Access Compliance Report Public Rights-of-Way (Curb Ramps)

Main Street: DODGE_AVE Cross Street: ETON_PL Location: SE

ADA ID: RPRK220127130854 Ramp Type: Type 4 - Parallel Initial Pass/Fail: Pass Overall Compliance: No Severity Score: 0

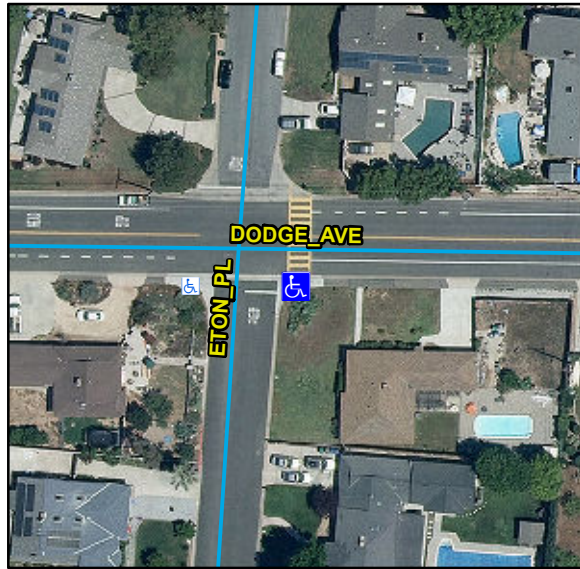
Remove & Replace Landing.

R304.2.1, STD 1115
